RFB 2025-04, Addendum No. 1 Rancho Cañada del Oro Stock Pond Restoration Project

To: Request for Bids Recipients
From: Rachel Clemons, Watershed Restoration Specialist
Date: 3/7/2025
Re: Addendum 1 for RFB 2025-04

Rancho Cañada del Oro Stock Pond Restoration Project

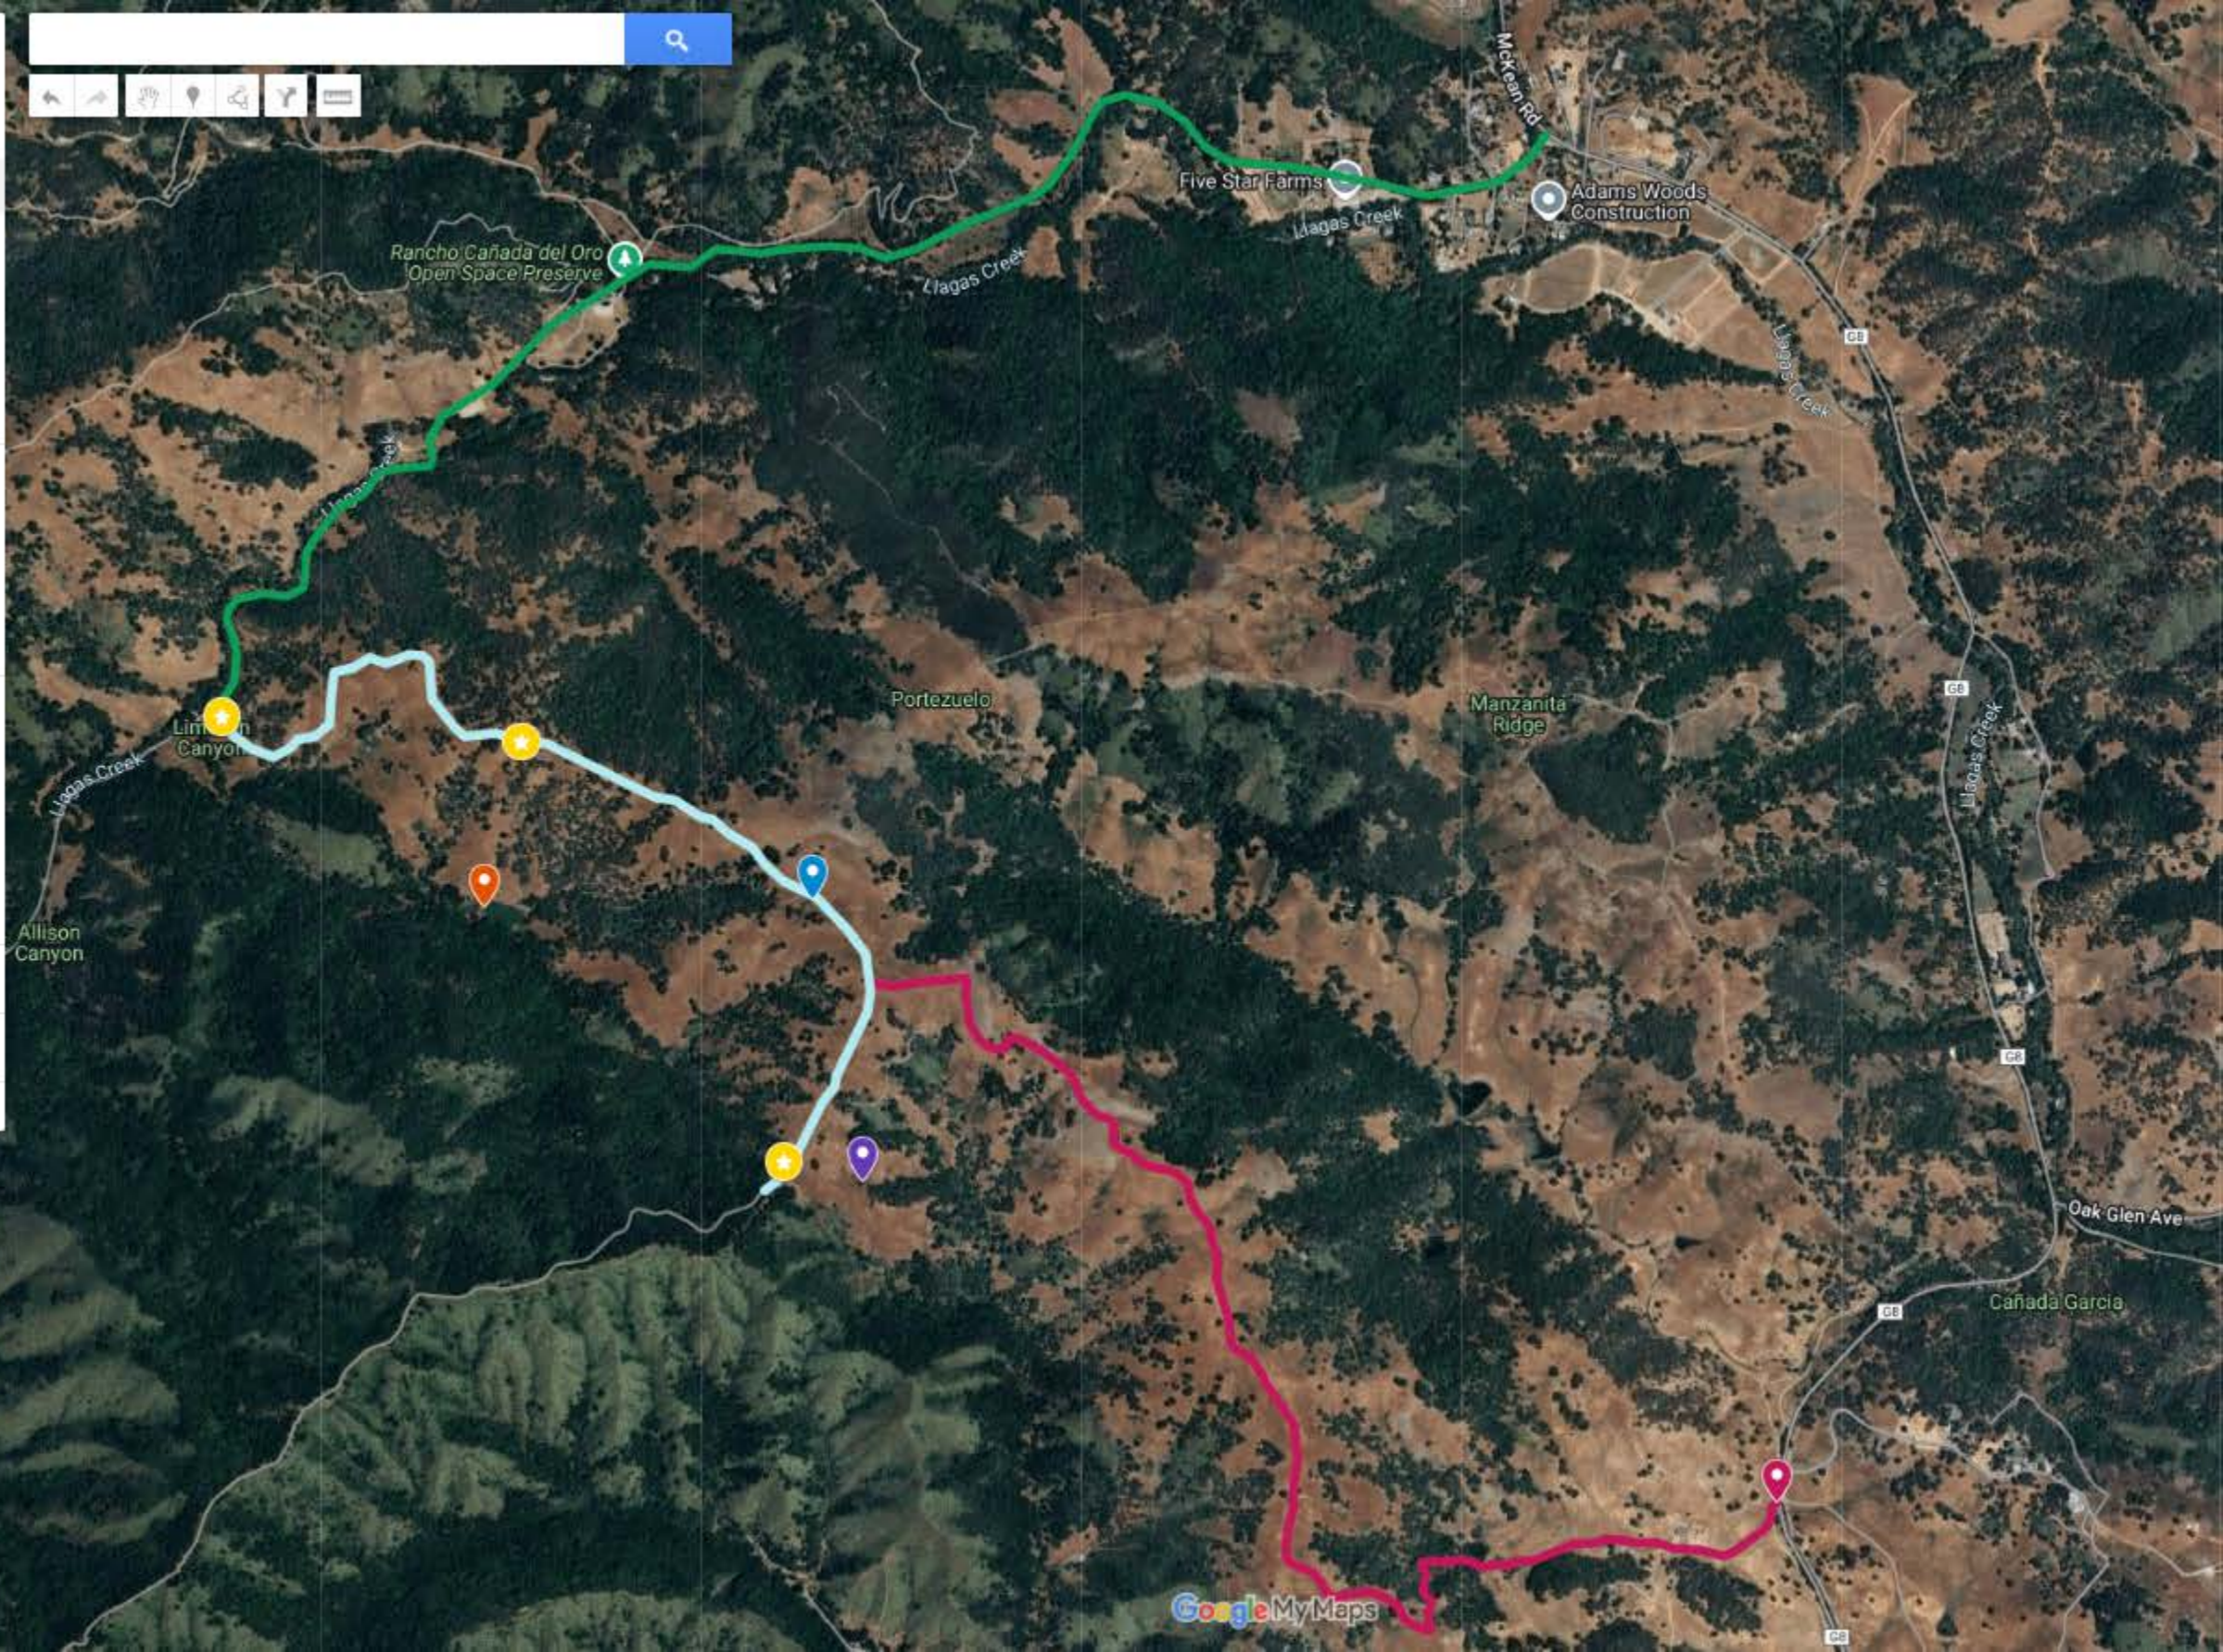
8. Can the Contractor access the site from via the Uvas Road entrance to Rancho Cañada del Oro Open Space Preserve?

Yes. The alternative access route is from County Road G8/Uvas Road (see Attachment 1). This unnamed ranch road on Authority-owned property is ~2.4 miles long and connects to Twin Creeks Road, between RC-07 and RC-10. The road is steep and narrow; long trailers, "low boys", or other lengthy pieces of equipment cannot make the tight turns. However, excavators, short-end dumps, or other small equipment can and have used the road. The Authority will permit the Contractor to track equipment up the road, and to restore the road to its prior condition or use rubber-tracked equipment. It is the Contractor's responsibility to verify their equipment can safely use the road. At the top of the road near its convergence with Twin Creeks Road, there is a very tight turn due to cattle fencing. The Authority can remove/reinstall the fencing in coordination with the Contractor to allow equipment access. The Contractor may conduct minor vegetation trimming and removal along the alternate access road as necessary.

TYPICAL STAFF GAGE DESIGN

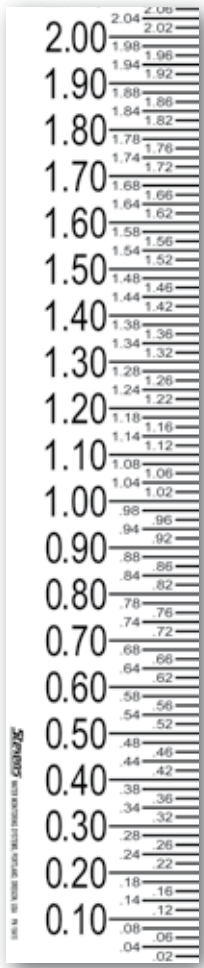
24. Is there a detail for the staff gages to be installed?

A detail is not included in the Construction Drawings, but further information has been provided in Attachment 2 to this Addendum.

One staff gage will be placed in each of the three ponds, per the Construction Drawings. Porcelain-enameled iron staff gage, Stevens Water Monitoring Systems, Inc. Style C or equivalent. Exact model numbers to be determined by the Authority.

Gages at RC-07 and RC-10 should be installed with three T-posts surrounding them, as shown in the photo below, in order to protect them from cattle damage. Typical installation detail is shown on the following page. Contractor will coordinate with the Authority on exact placement such that the top of the gage exceeds the outlet elevation by approximately one foot.
